MEMO TO: Prospective Bidders
FROM: Kimberly Toon, Purchasing Manager
SUBJECT: **Addendum #3:** NC Veterans Park Phase II
DUE DATE AND TIME: **APRIL 24, 2026; 2:00 p.m.**

A. The Bid Documents are hereby modified by this Addendum #3 dated April 16, 2026. To include the following:

North Carolina
Veterans Park
Phase II
300 Bragg Blvd.
Fayetteville, NC
28301

SHEET NUMBER
C-503

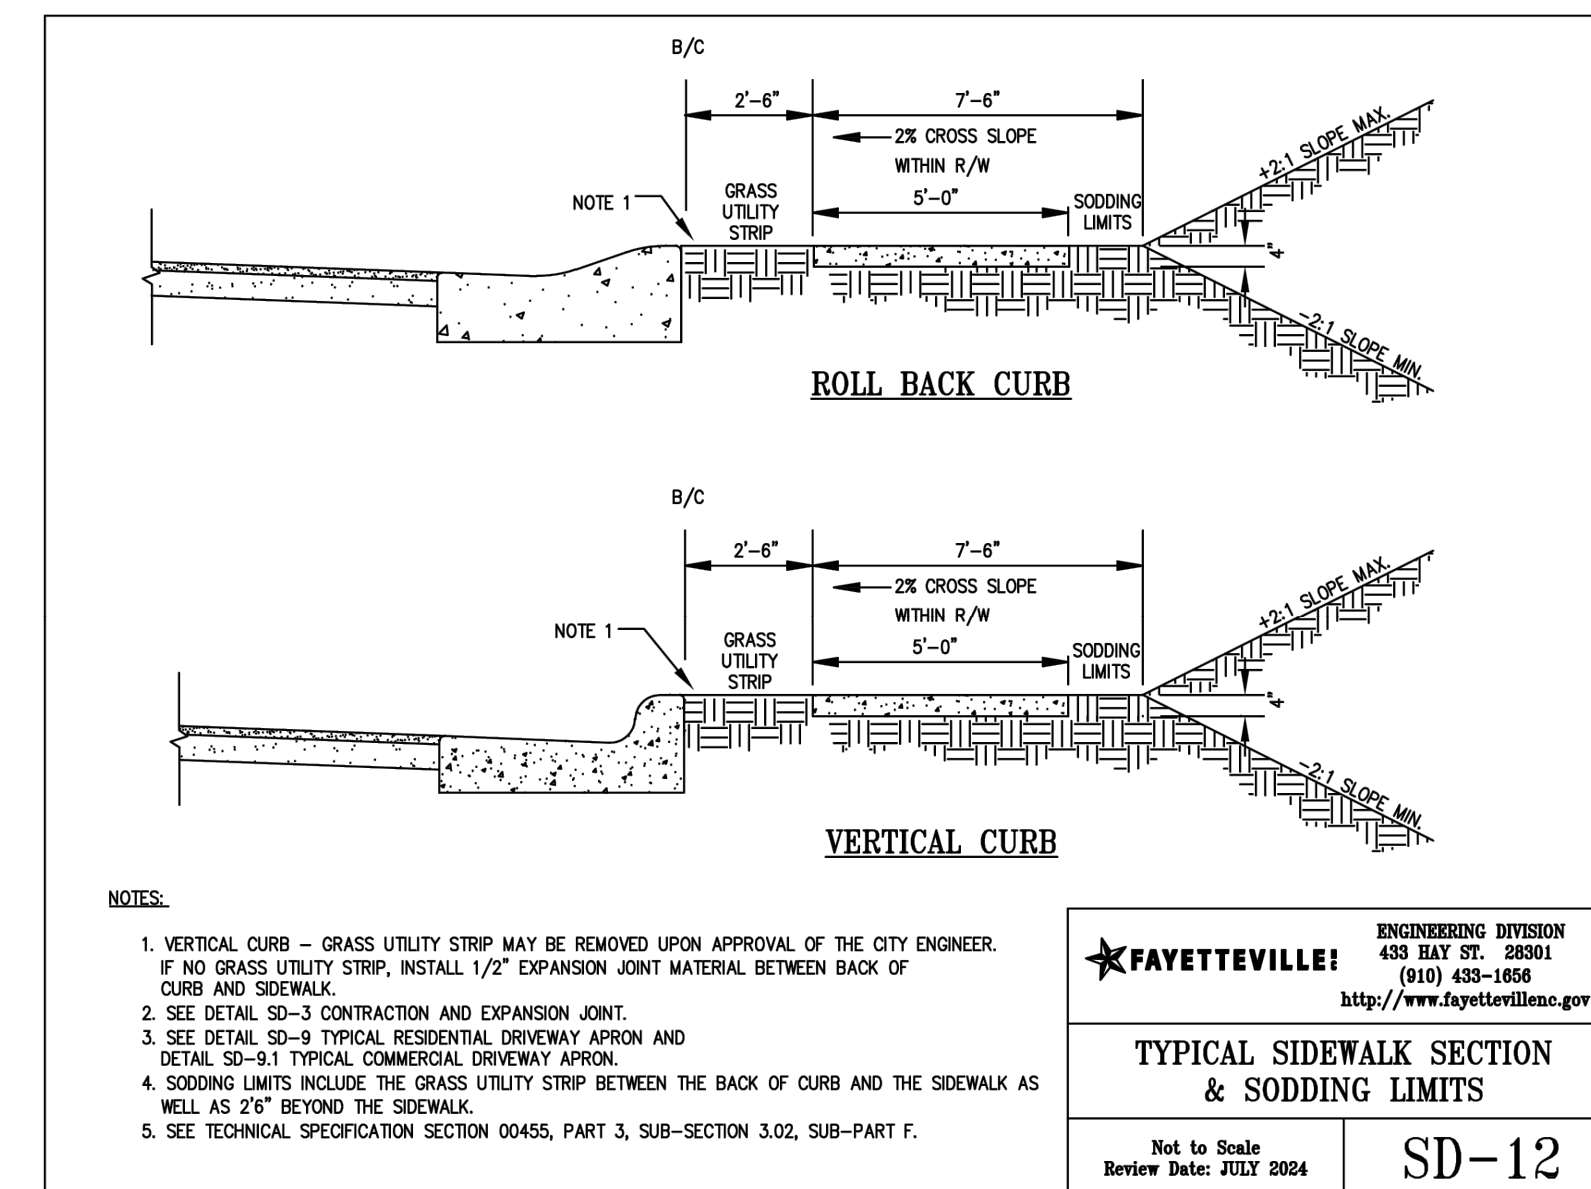
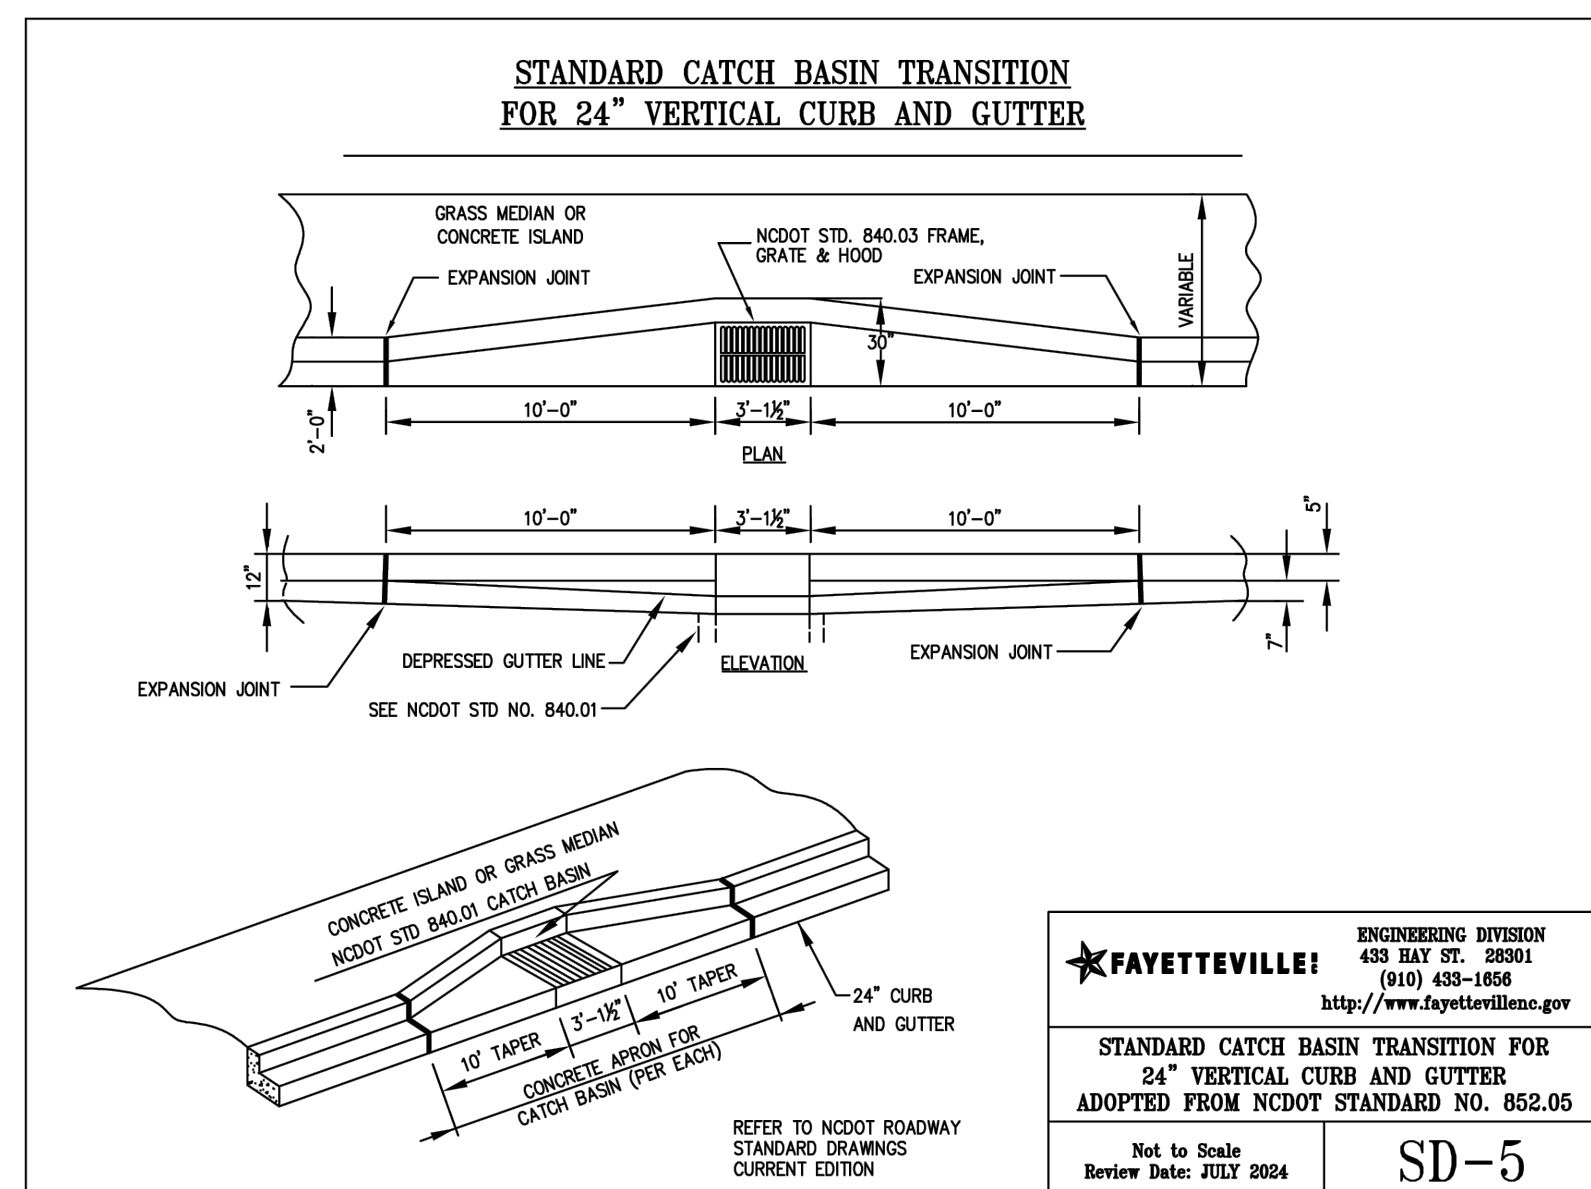
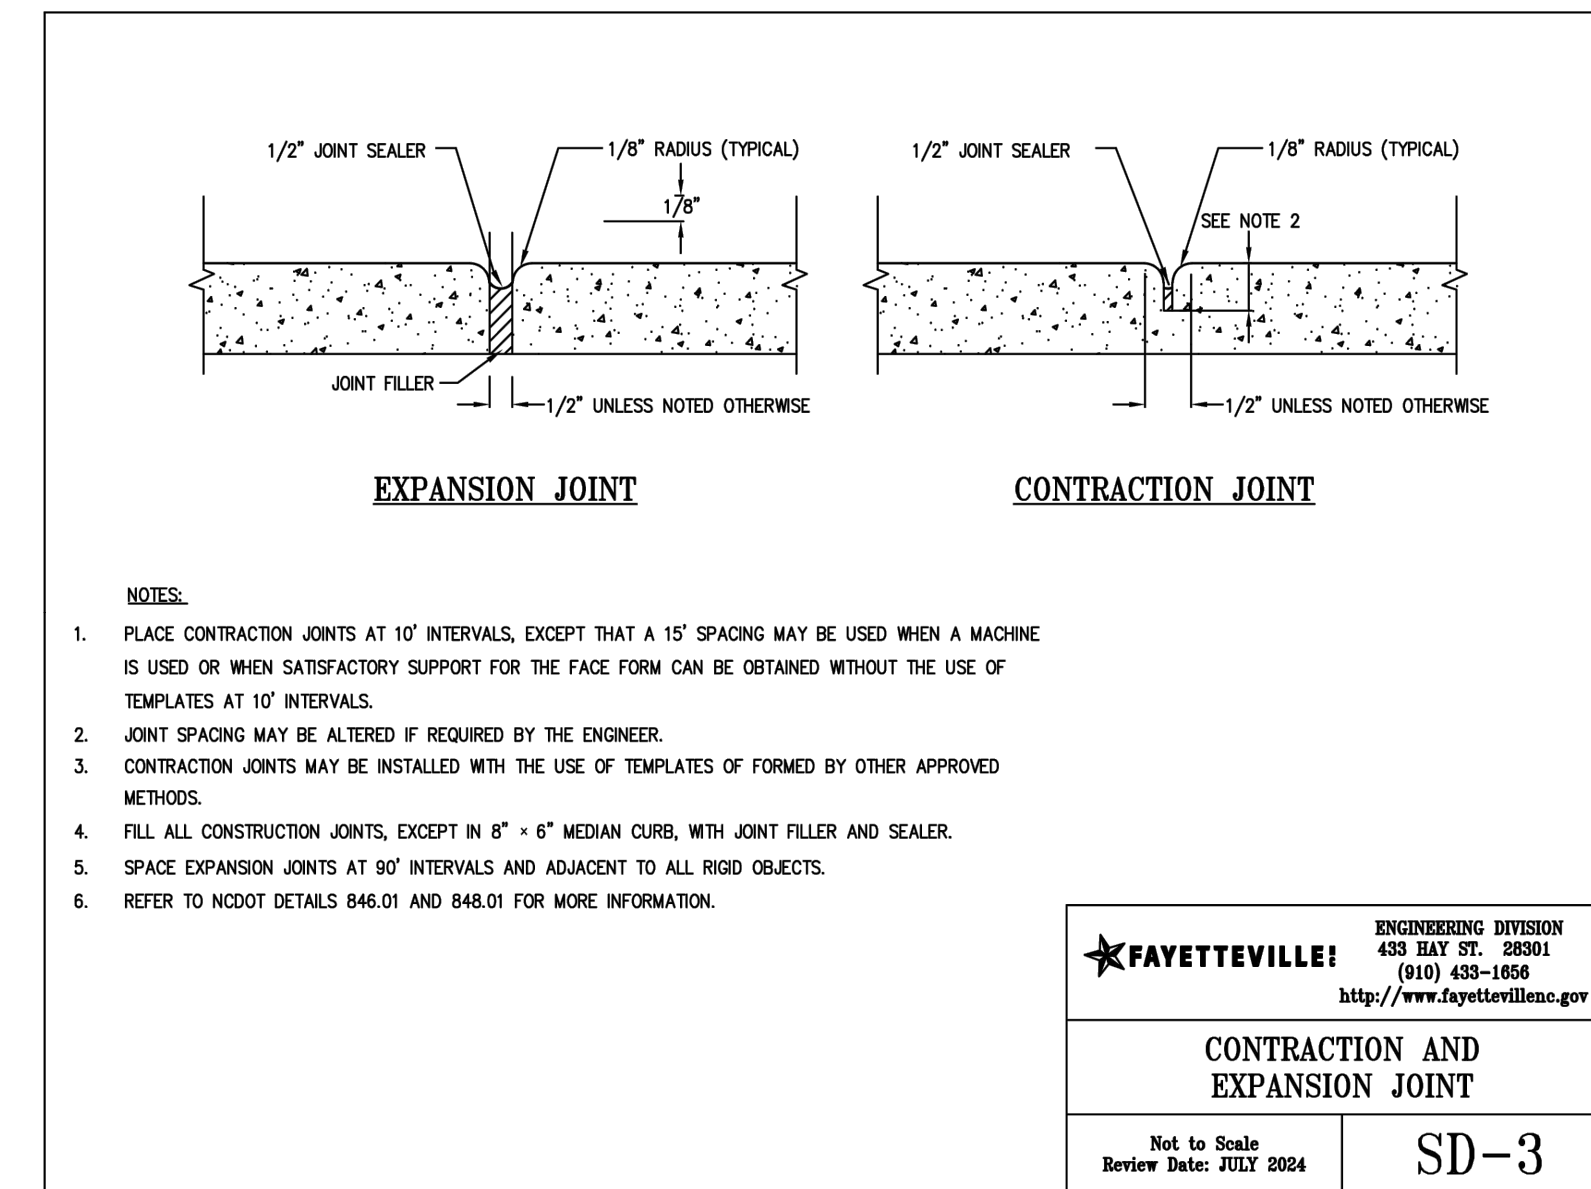
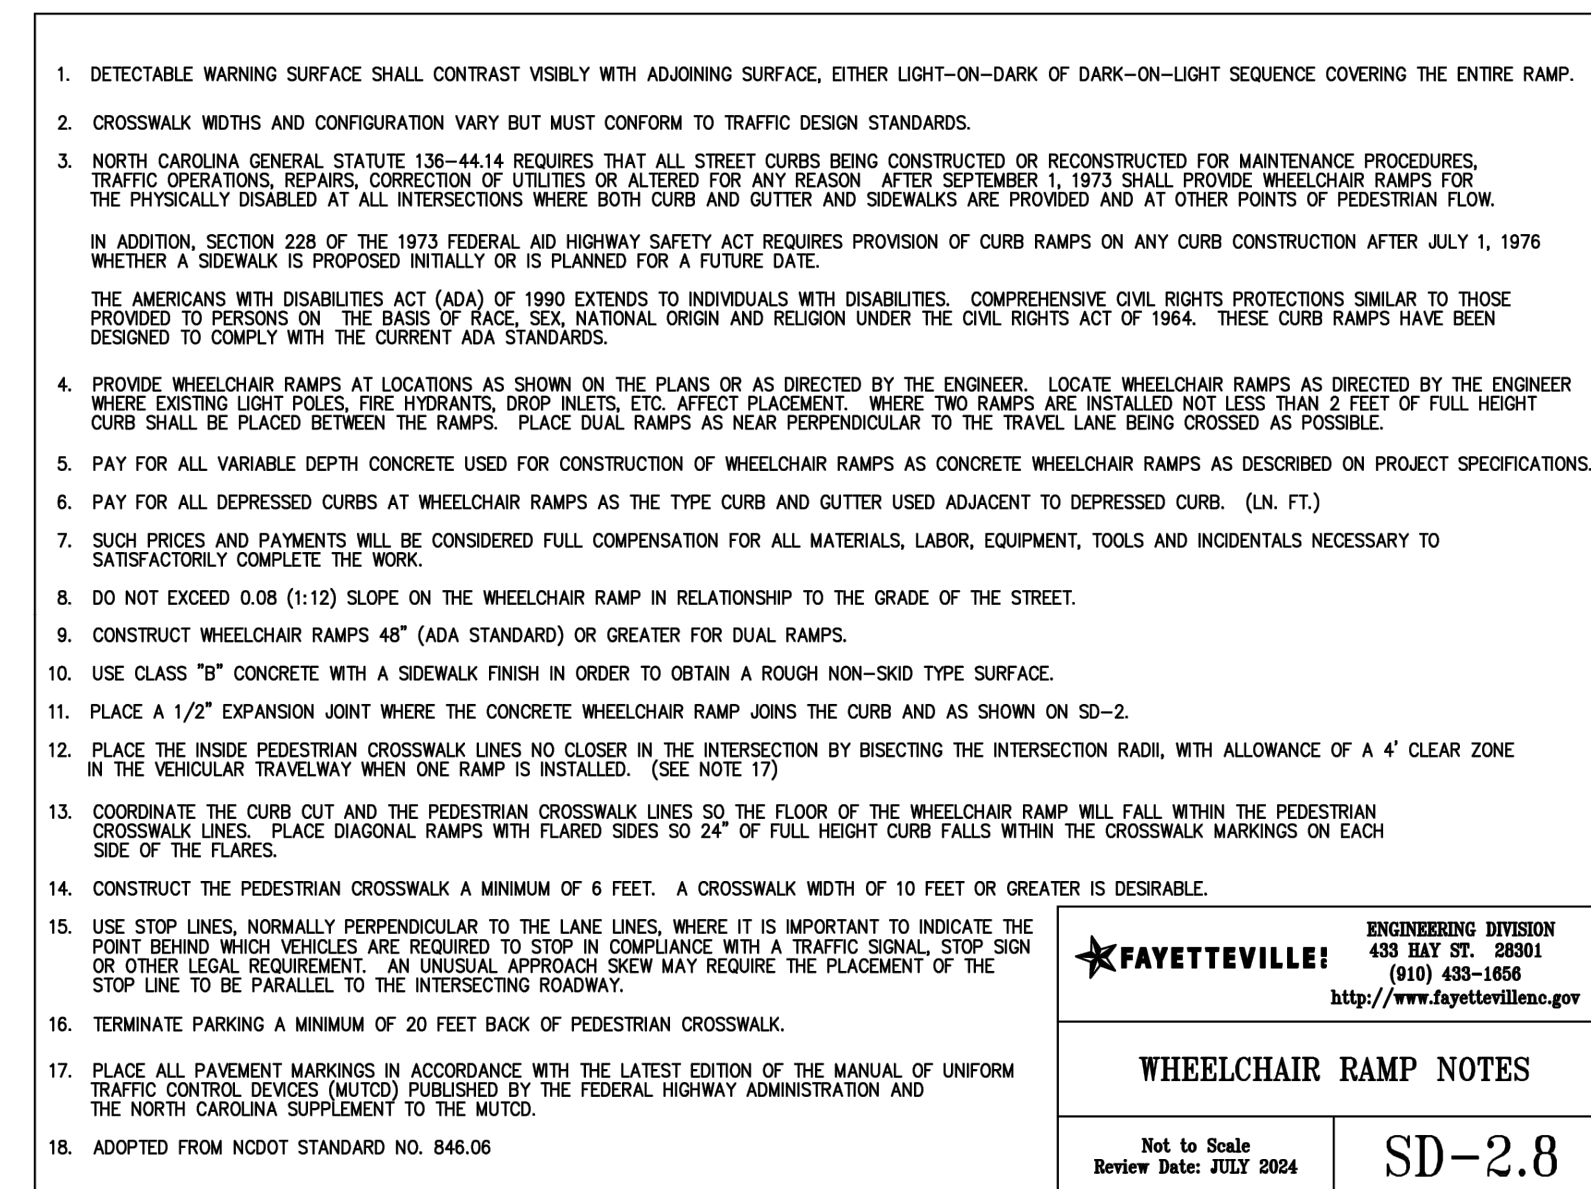
13. **Question:** SD-10 on sheet C-503 (Handrail)—where is this located on the plans?

Answer: This detail has been updated and issued in this Addendum.
